UNITED STATES PATENT AND TRADEMARK OFFICE

APPLICATION NO.	FILING DATE	FIRST NAMED INVENTOR	ATTORNEY DOCKET NO.	CONFIRMATION NO.
10/814,840	03/31/2004	Douglas R. Woellner	200313398-1	6491
22879	7590	09/28/2005	EXAMINER	
HEWLETT PACKARD COMPANY P O BOX 272400, 3404 E. HARMONY ROAD INTELLECTUAL PROPERTY ADMINISTRATION FORT COLLINS, CO 80527-2400			NGUYEN, TRUC T	
			ART UNIT	PAPER NUMBER
			2833

Office Action Summary

EXAMINER'S ATTACHMENT FOR 10/814, 840

FIG. 1

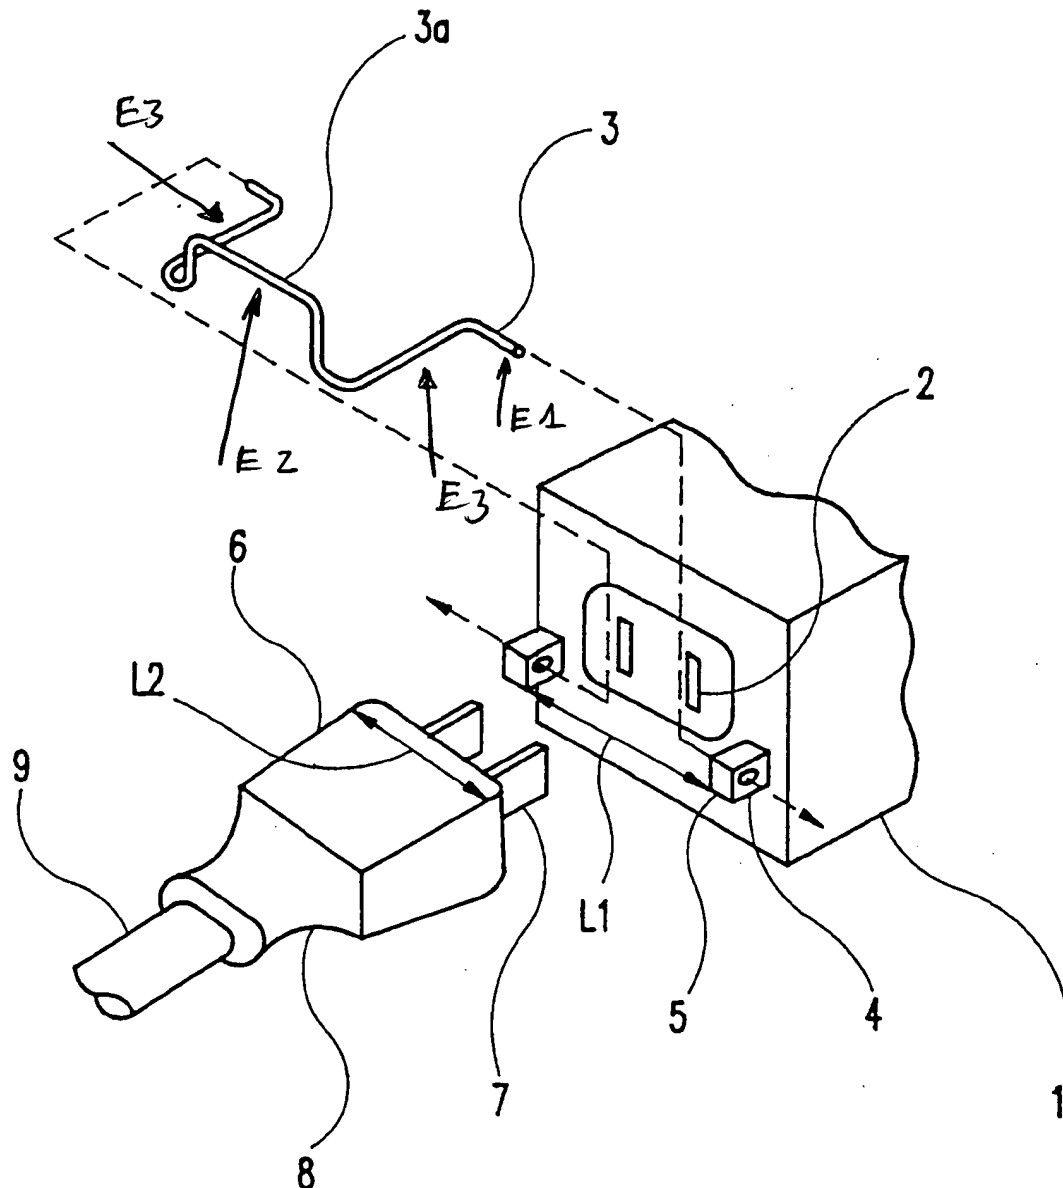
4. Claims 51, 53-57 are rejected under 35 U.S.C. 102(b) as being anticipated by Shibuya et al. (US 5,593,313).

Shibuya et al. disclose:

a circuitry housing (1) having a slot (hole in member 4, Figure 1);

a cable plug (6) having a lip (8);

a U-shaped clip body (3), comprising:

a first retention (E2, Examiner's attachment) engages the lip;

a second retention (E1) engages the slot.
